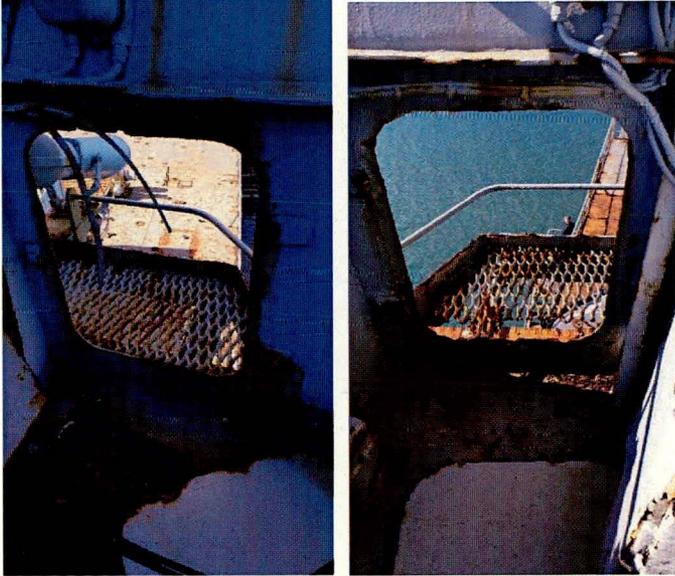
TASK NO.	TASK/DESCRIPTION	NOTES
H4.03	<p data-bbox="408 389 660 423"><b>Upper Deck Doors</b></p>  <p data-bbox="408 1682 1214 1850">Many upper deck doors are seized or stiff to move with no ability to securely close. REFURBISH doors to include renewal of rubber seals and repair any excessively corroded areas. All clips to be freed up and greased, or RENEWED if beyond repair. Doors will be placed in priority order with list provided to the Contractor prior to RPSD. REPRESENTATION on completion of any required work.</p> <p data-bbox="408 1865 1098 1895">ALLOW for 30 doors. ALLOW for 60m<sup>2</sup> REPRESENTATION.</p>	<p data-bbox="1249 394 1437 566">Awaiting Escape, Evacuation and Rescue report to aid priority listing.</p> <p data-bbox="1249 595 1437 703">IAW Paint scheme -General 12 and Annex B refer.</p>

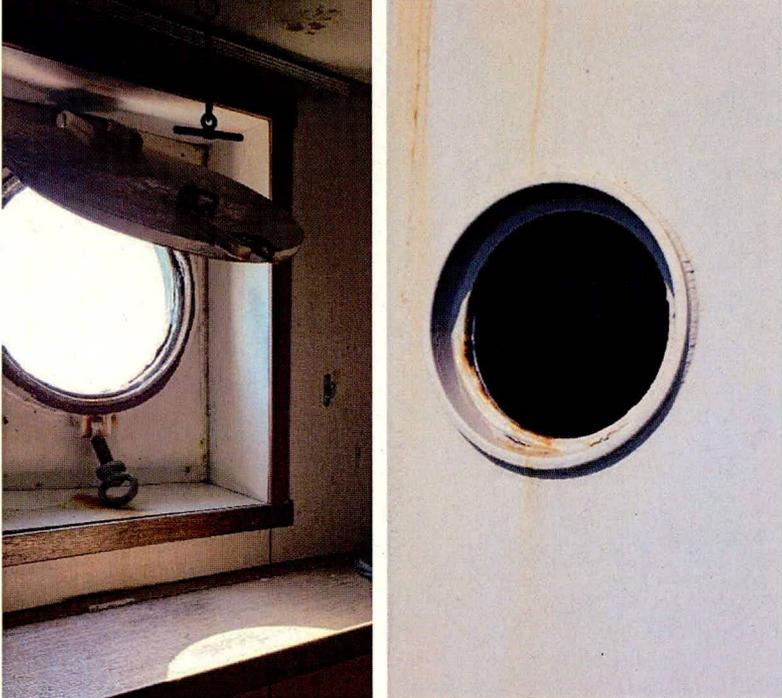
TASK NO.	TASK/DESCRIPTION	NOTES
	H4 EXTERNAL DOORS, OPENINGS AND HATCHES	
H4.05	<p data-bbox="411 389 612 421"><b>Cabin Porthole</b></p> <div data-bbox="408 439 1190 1137">  </div> <p data-bbox="411 1155 1214 1240">Cabin 01Z0 porthole flap is seized open and porthole glass has become detached leaving an opening for rain ingress. Hinged flap to be freed up and sealed shut with appropriate weatherproof sealant.</p>
